**REPORT TO THE CALGARY PLANNING COMMISSION**

<b>DEVELOPMENT PERMIT</b>	<b>ITEM NO: 07</b>	
	CPC DATE:	2007 September 20 2007 July 26
	<b>DP NO:</b>	DP2006-1969

BELTLINE  
(Ward 8 - Alderman King)

## **SUPPLEMENTARY REPORT**

CENTRE CITY PLAN  
LAUSSANE MONTREUX  
SEPTEMBER 05 SHADOW AT 15.00

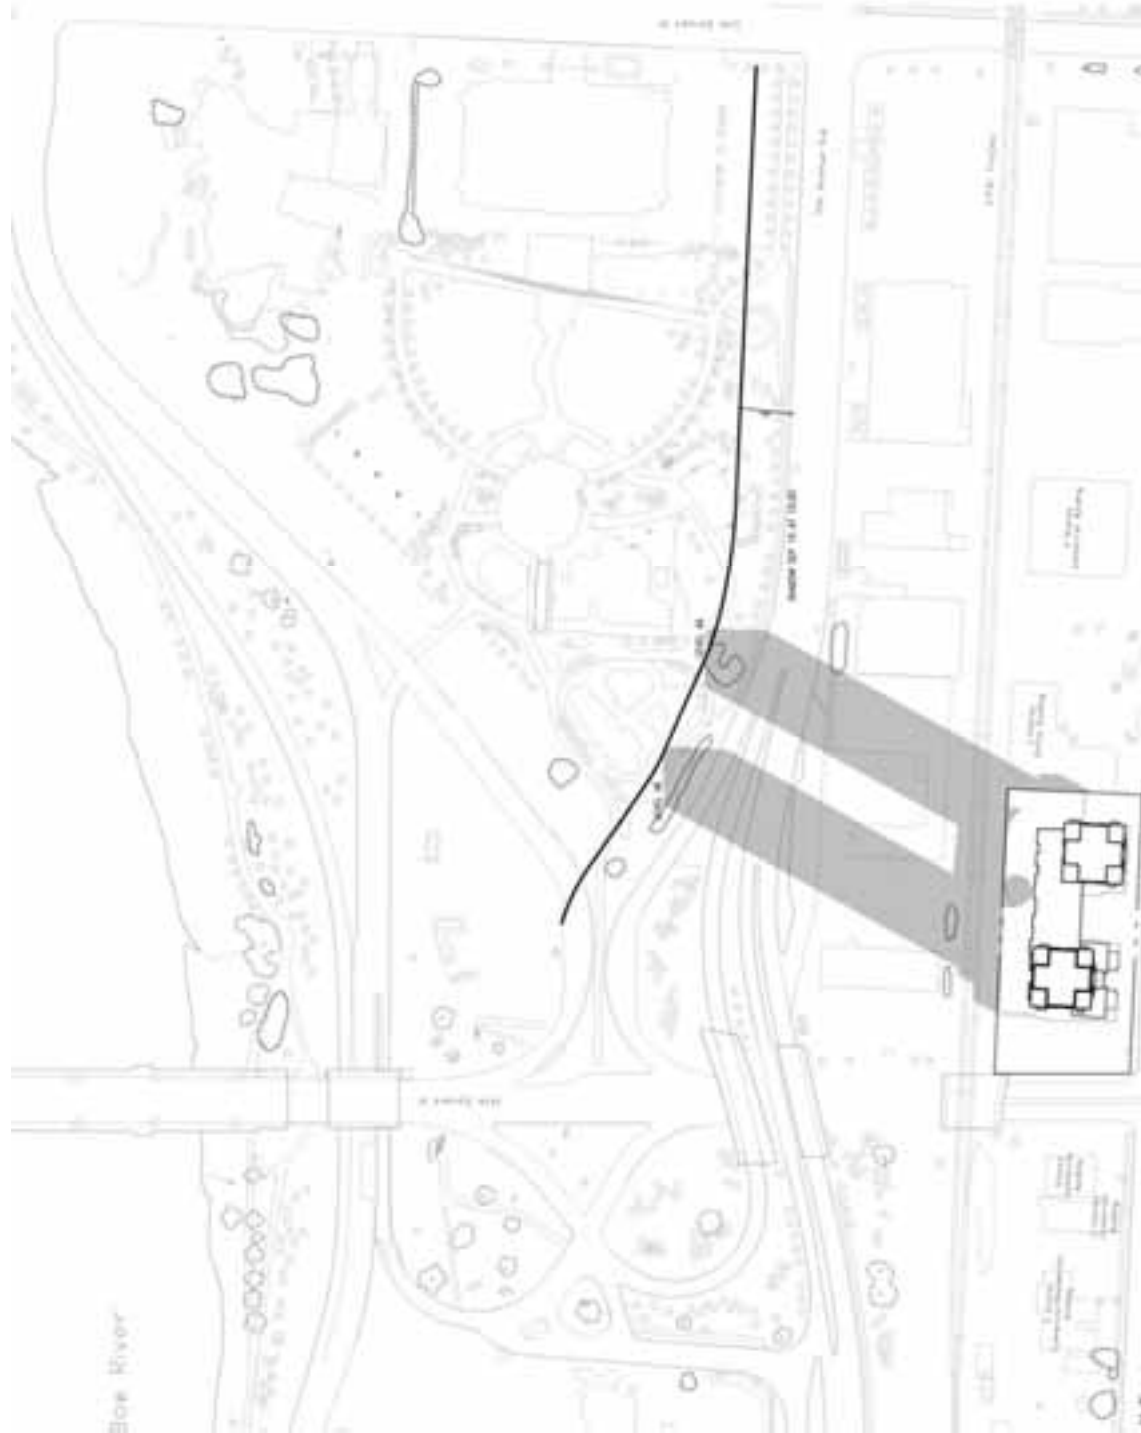
- a) On September 05, the western tower encroaches into the shadow protected area between 3pm and 4pm.
- b) On September 10, the eastern tower encroaches into the shadow protected area between 2pm and 3pm (minimally), while both towers encroach into the shadow protected area between 3pm and 4pm.
- c) On September 21<sup>s</sup>, the eastern tower encroaches into the shadow protected area between 1pm and 2pm (marginally), while both towers encroach into the shadow protected area after 2pm. This is the greatest impact to the park.

In order to comply with the Centre City Plan, a substantial reduction in the height of the towers would be required. To meet the shadow restrictions, a reduction of 9 storeys (from 46 to 37 storeys) would be required for the east tower, and a reduction of 12 storeys (from 45 to 33 storeys) would be required. The applicant has indicated that to reduce the heights to comply with the Centre City Plan would be a substantial redesign of the project.

CENTRE CITY PLAN  
LAUSSANE MONTREUX  
SEPTEMBER 21 SHADOW AT 14.00  
AND 18.00 PM

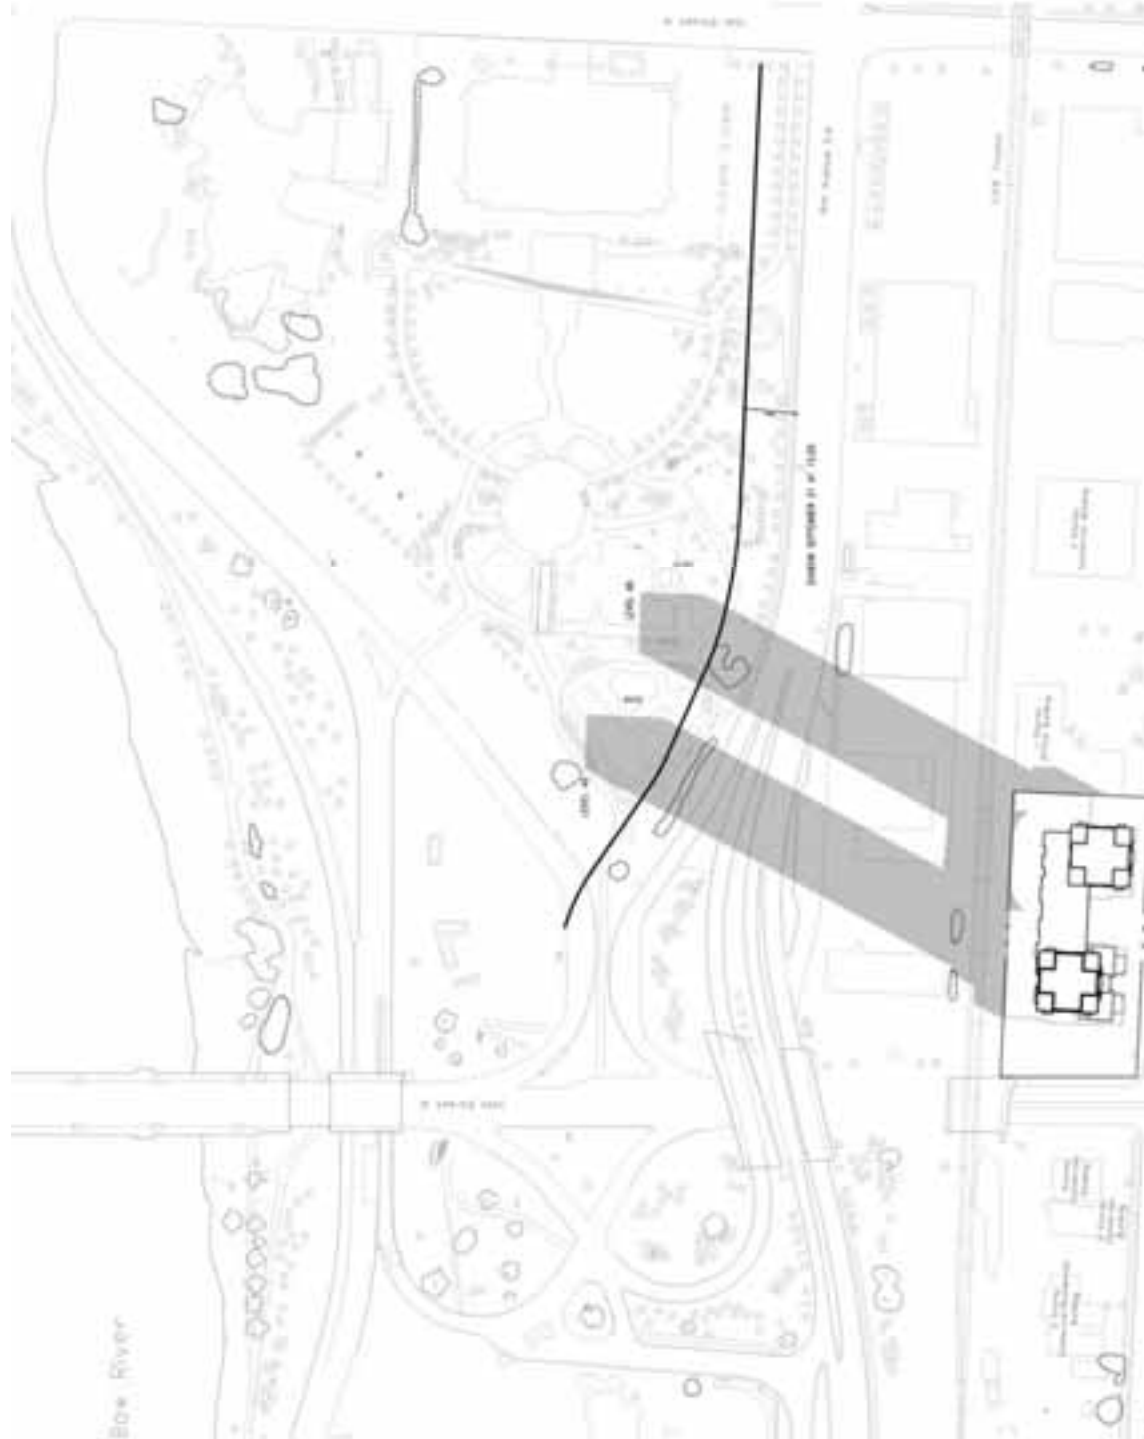
Correspondingly, on March 21, the impact is the same as September 21, with the towers falling outside the shadow protected area from April 07 onward.
